DUKE POWER

January 25, 1996

Subject: Catawba Nuclear Station - York County, South Carolina
Permit #76-2A-084
Standby Nuclear Service Water Pond Level Increase to Elev. 574
File: CN-702.11

SNSW POND DISCHARGE HEADWALL PROPOSED MODIF.
 REPLACE EXISTING ONE FOOT HIGH PLATE WITH
 3 FOOT HIGH CONCRETE OR STEEL BARRIER

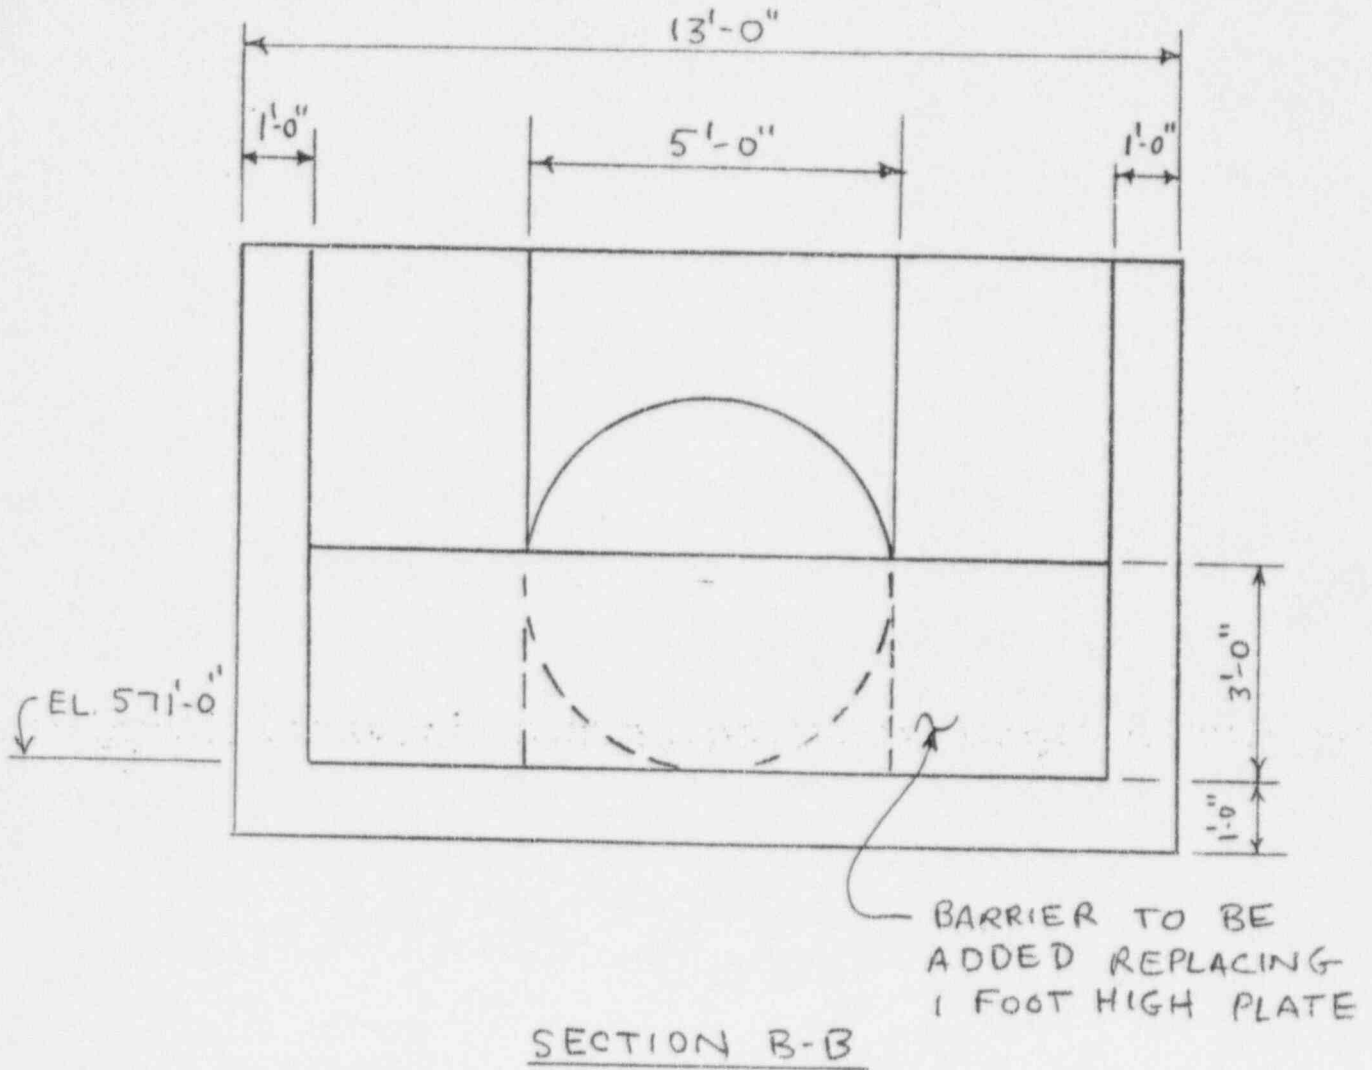
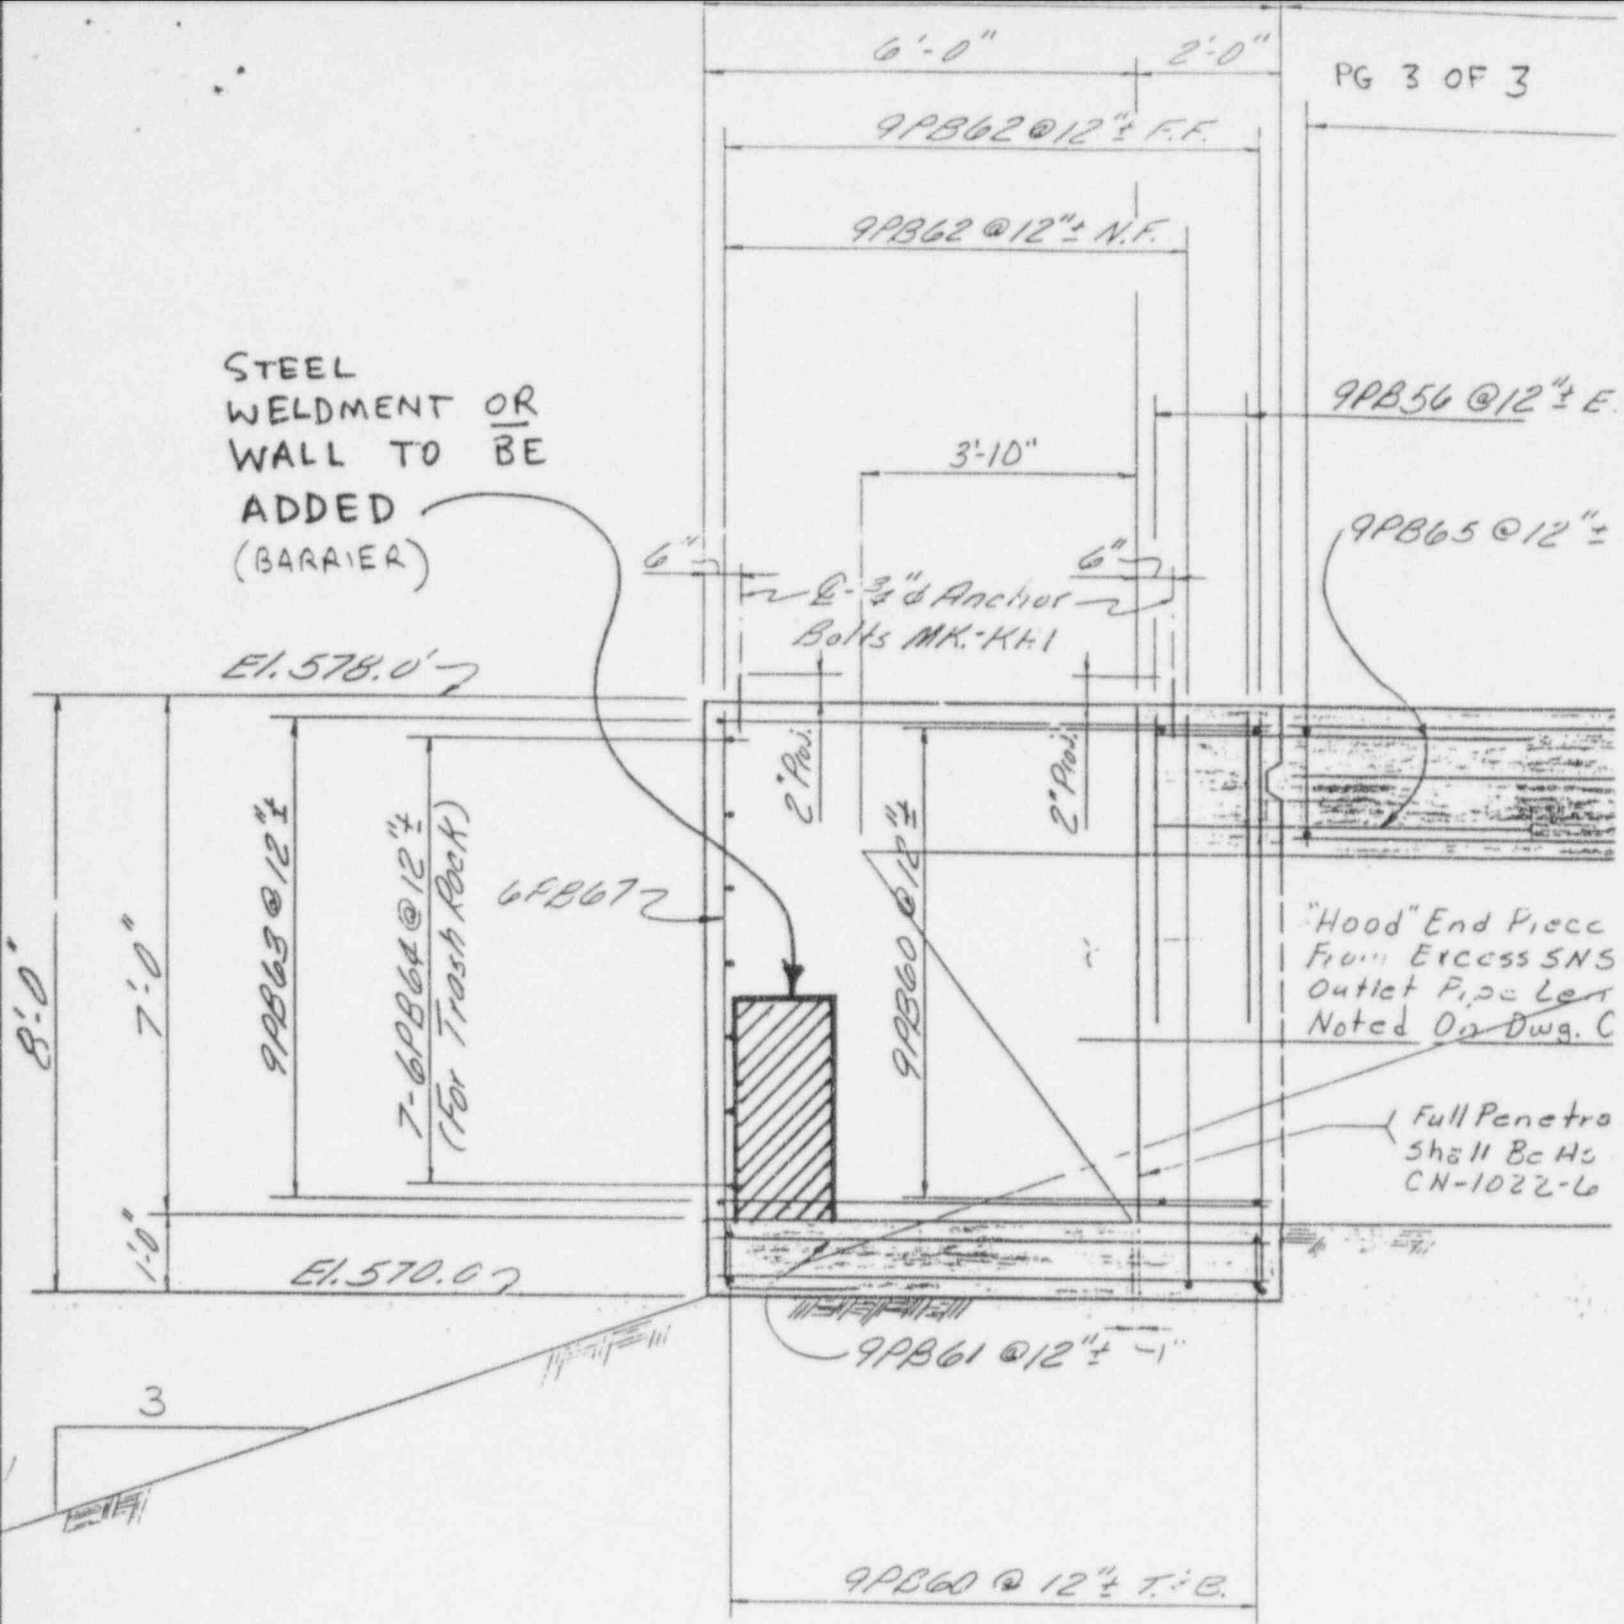
The pond level is presently maintained at elevation 572'. The pond level will be increased to elevation 574' by obstructing two feet of the overflow pipe. Duke Power would replace an existing 1 foot steel plate located in the discharge headwall with a 3 foot steel or concrete plate. (See attached engineering sketches, 3 pages)
